Re: Petition of New England Power Company for a Grant of Location for Electric Transmission Line (N-192 Cable Replacement Project)

In advance of the City Council's May 16th continued public hearing, New England Power Company ("Company" or "NEP") writes to respond to the questions in your May 16th letter and also to address additional comments from the public and Commissioner Collins.

**Figure 7.4-2
Magnetic Field at Ground Level With and
Without Steel Plates (Cable Current: 600 A)**

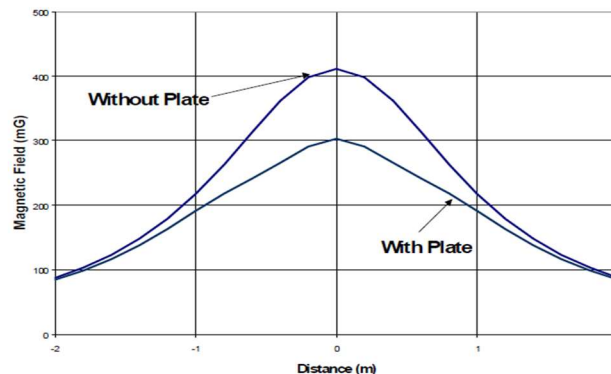
At the April 5 hearing, there was some discussion that steel plating has the principal effect of redirecting EMFs to the left and right of the transmission lines, rather than in a more vertical bearing. Please provide modeling results that show the predicted EMF levels 10 feet and 25 feet on either side of the duct bank if it is buried less than 2.5 feet and a steel plate is placed over it.

There is ample evidence that placing a steel plate over a buried power line will result in some reduction of the magnetic field both directly above and a short distance to either side. However, the effectiveness of the plate will be determined by multiple factors, some of which might not be known until after installation of the plates. We have provided below an example from Electric Power Research Institute (EPRI)¹ that illustrates the effect of installing a steel plate above an example buried power line. In this example, the plate results in an approximately 25% reduction in the MF immediately above the duct bank centerline. At distances of approximately 6.6 feet (2m) or greater the reduction in MF levels is very small.
